BID ADDENDUM NO. (1)

10/14/2025
South Seneca CSD
2022 Capital Improvement Phase II
2541.040

OVID JR/SR HIGH SCHOOL SED#: 56-05-01-04-0-001-025
INTERLAKEN ELEMENTARY SCHOOL SED#: 56-05-01-04-0-004-026

The following Addendum items shall be considered a part of the contract documents prepared by HUNT ENGINEERS, ARCHITECTS, LAND SURVEYORS & LANDSCAPE ARCHITECT, DPC.
Bid Document date of 10/03/2025

1 CAFETERIA WAINSCOT WALL TILE INSTALLATION PATTERN - ADDENDUM
 3/8" = 1'-0"

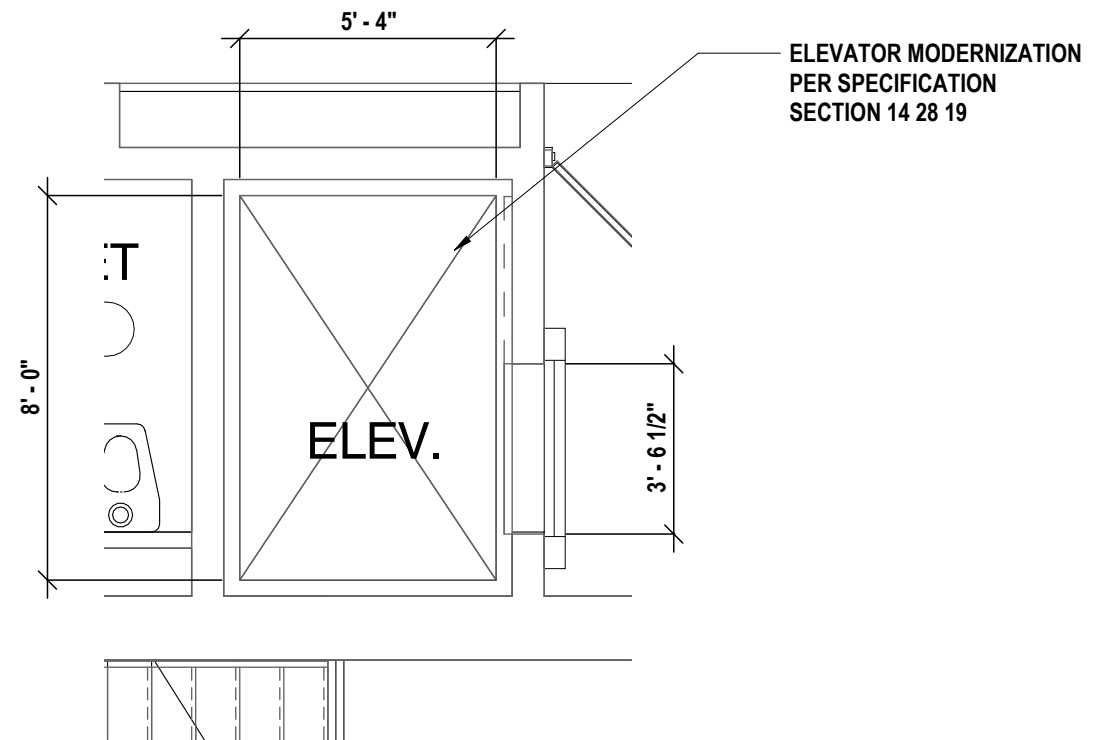
ITEM AD1-8 Refer to HS-A8.2 - FIRST FLOOR WALL FINISH PLAN - PARTIAL AREA A, C, & D

AMEND Detail 1 per AD1-A1 as issued by this addendum.

ADD note 10 to construction notes – interior wall finish to read – “WALL TO RECEIVE TILE, WT-1 AT WAINSCOT HEIGHT OF 4’-0” WITH PAINTED GYP ABOVE. PROVIDE TS-4 AS BASE. REFER TO 2/AD1-A1 FOR INSTALLATION DETAILS.”

ELEVATOR DRAWINGS

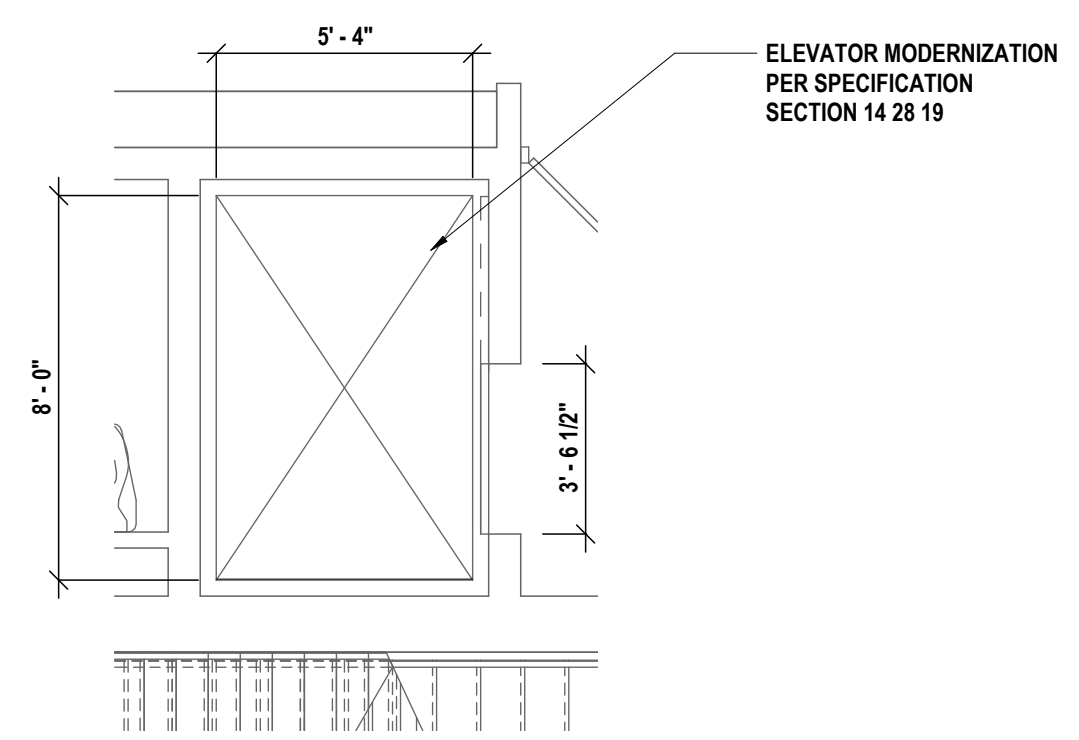
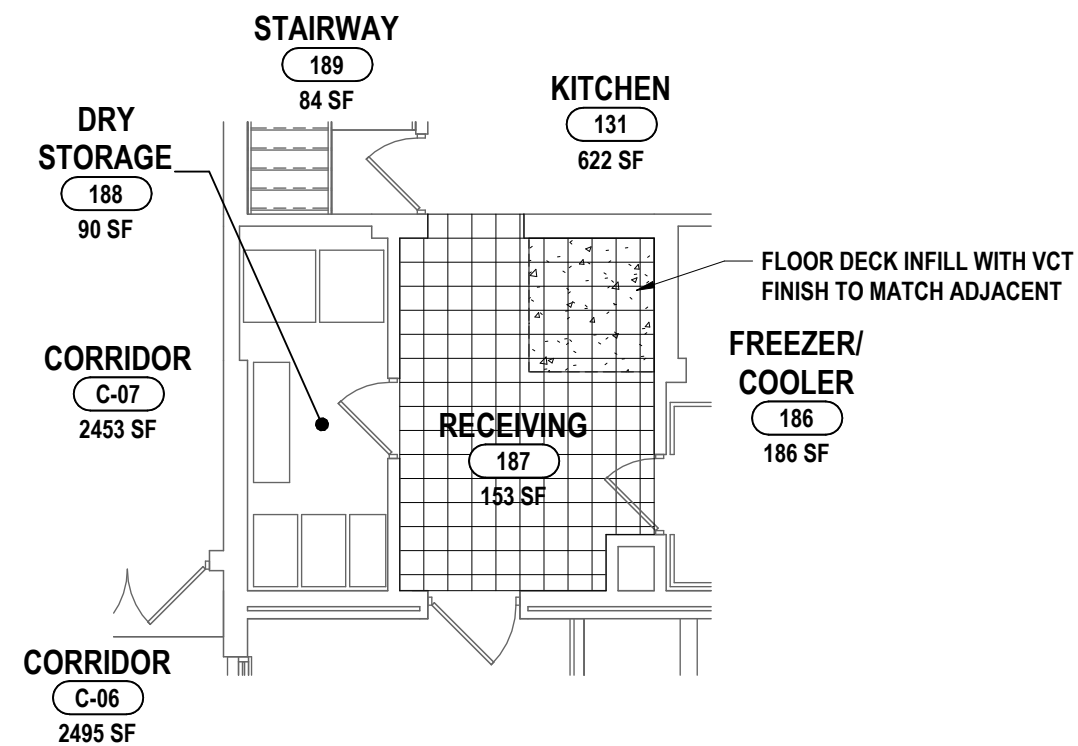
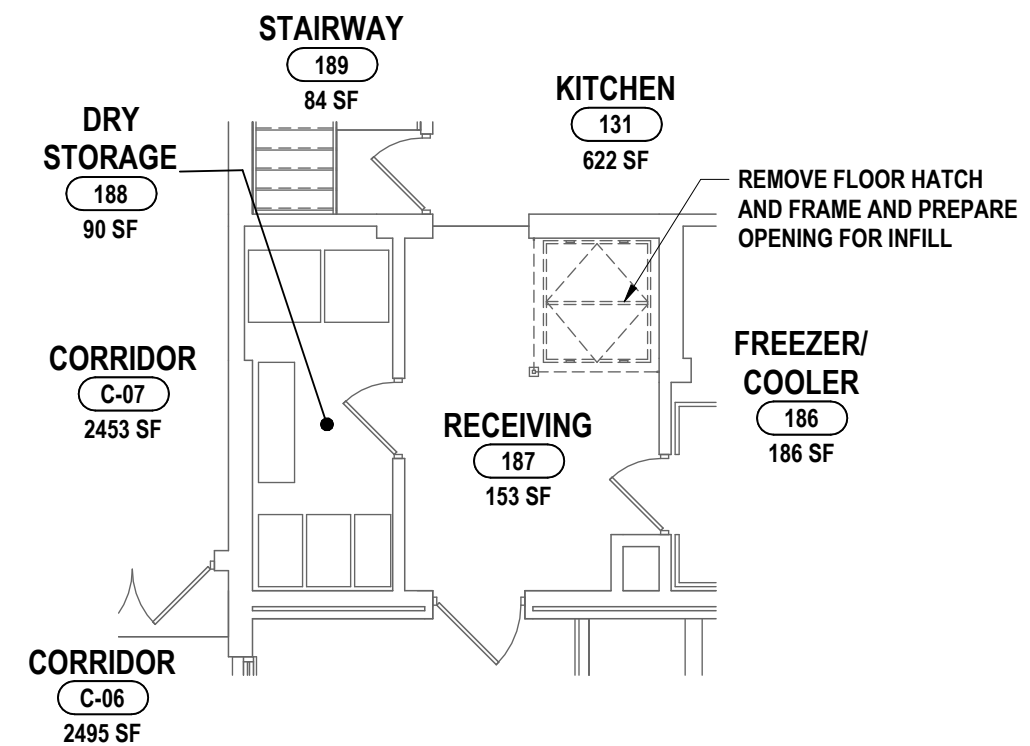
ITEM AD1-22 Refer to ES-A1.1 – TOILET ROOM PLANS, ELEVATIONS, AND DETAILS

ADD Details 8, 9, 10, & 11 per AD1-A2 - ELEVATOR DRAWINGS as issued by this addendum

ALTERNATES 1&2 REFLECTED CEILING PLANS
2022 CAPITAL IMPROVEMENT PROJECT PHASE 2
SOUTH SENECA CENTRAL SCHOOL DISTRICT
8326 N MAIN ST., INTERLAKEN, NY 14847

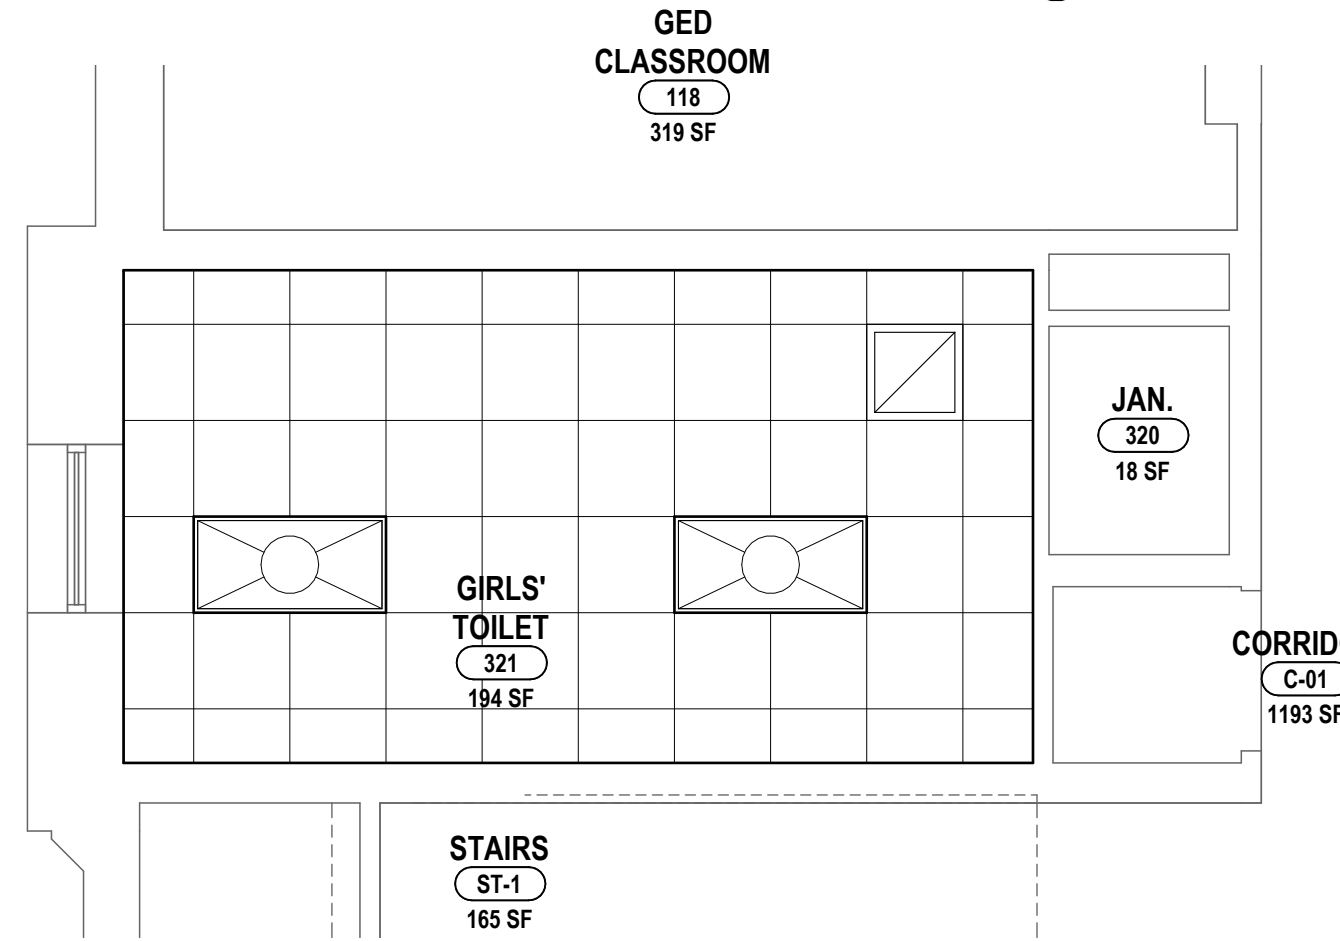
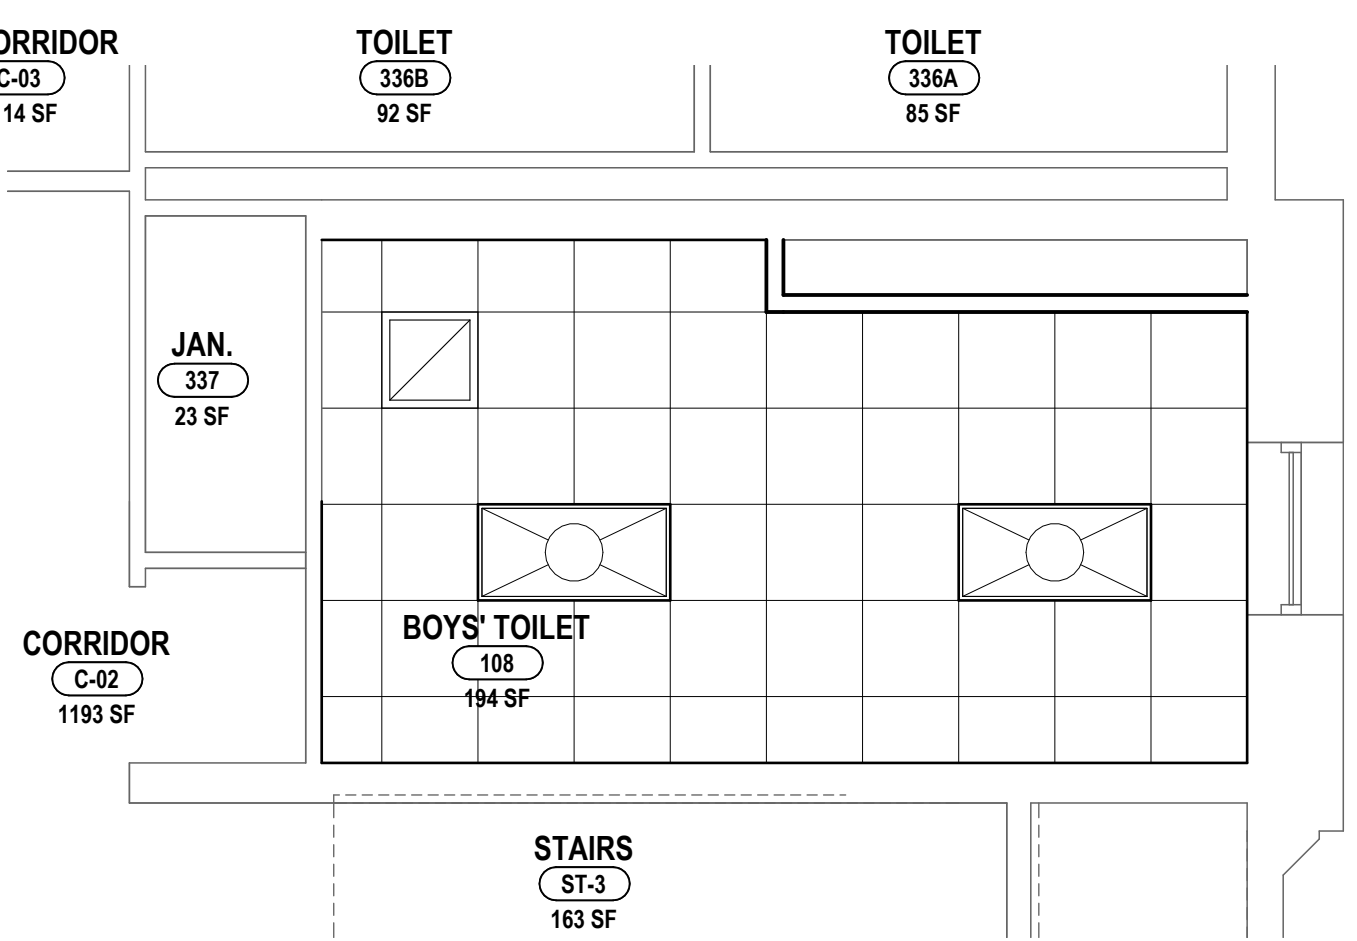
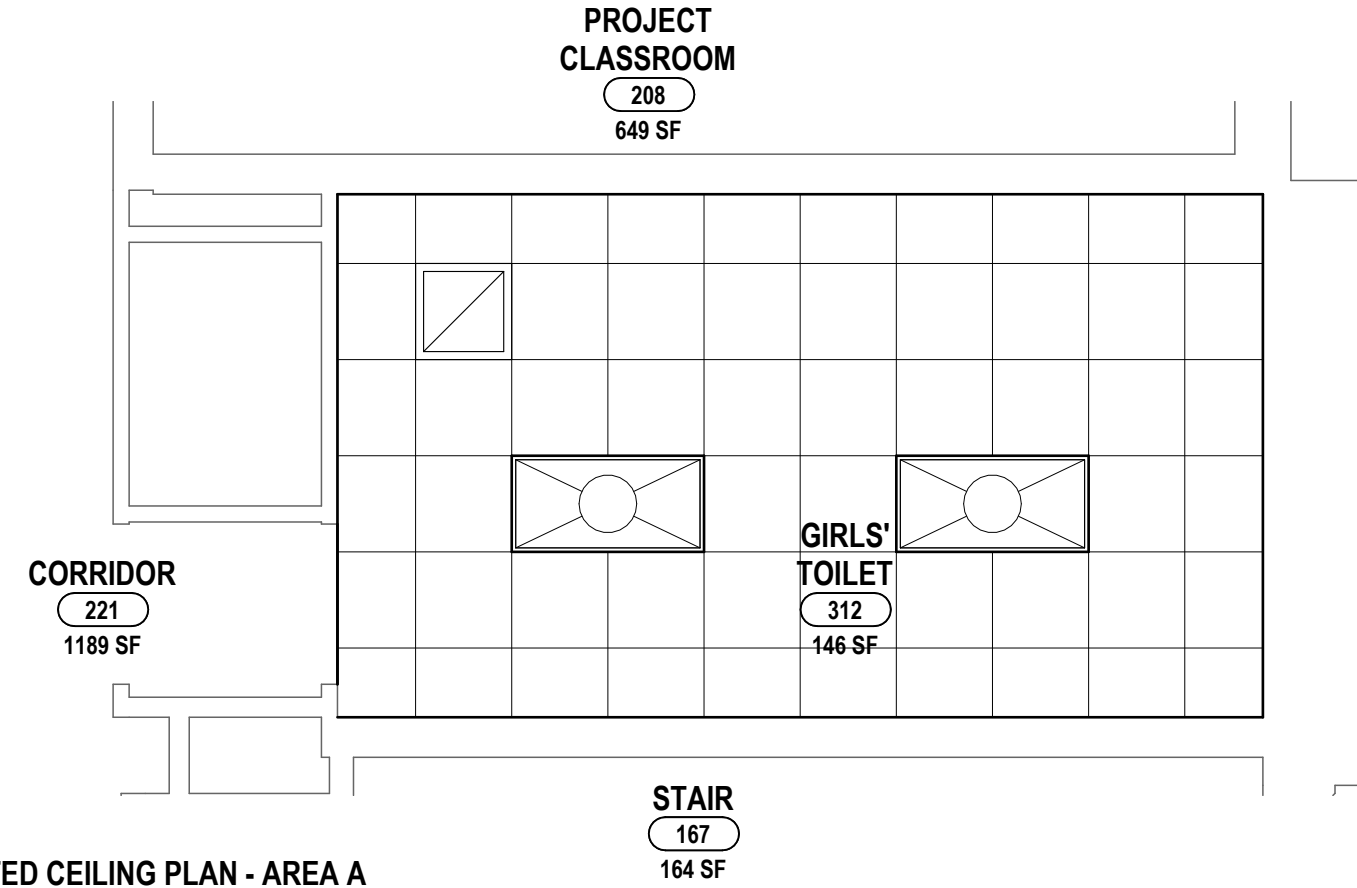
ITEM AD1-24 Refer to ES-A1.2 – ALTERNATE TOILET ROOM PLANS

ADD Details 5 & 6 per AD1-A3 - ALTERNATES 1&2 REFLECTED CEILING PLANS as issued by this addendum

15 SALT STORAGE EDGE SECTION
1/2" = 1'-0"

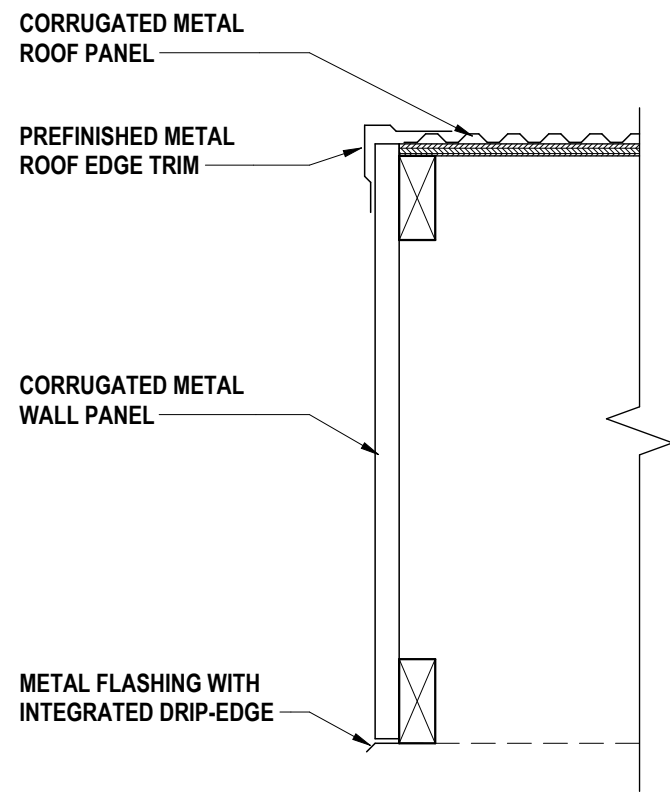
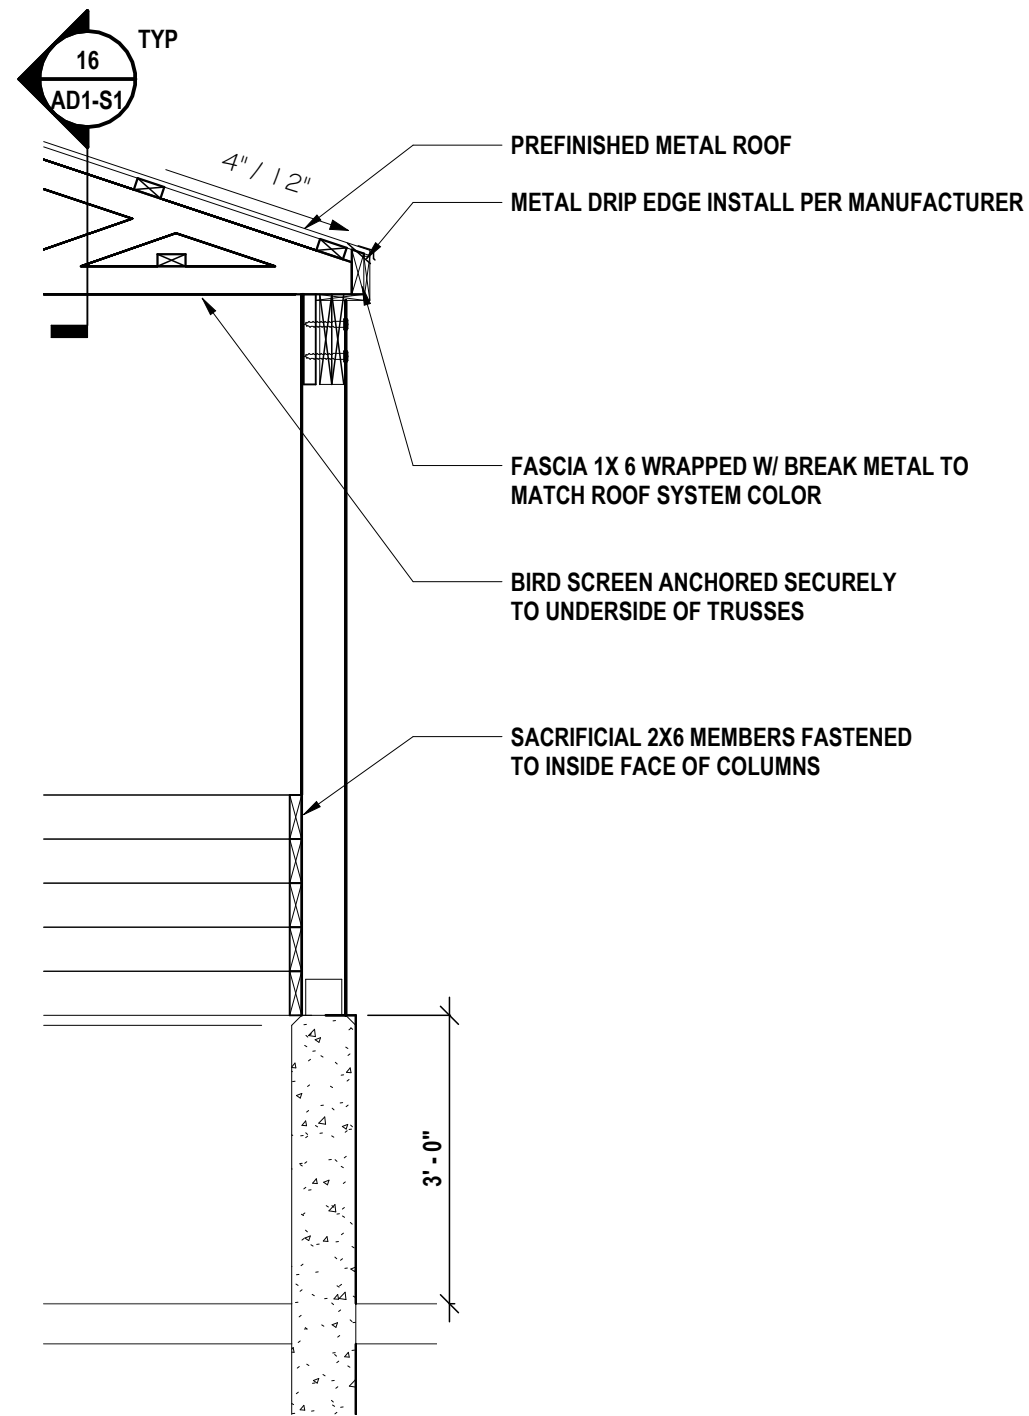
ITEM AD1-5 Refer to HS-S2.1 – FOUNDATION AND FRAMING DETAILS

ADD Details 15 & 16 per AD1-S1 – SALT STORAGE SHED DETAILS
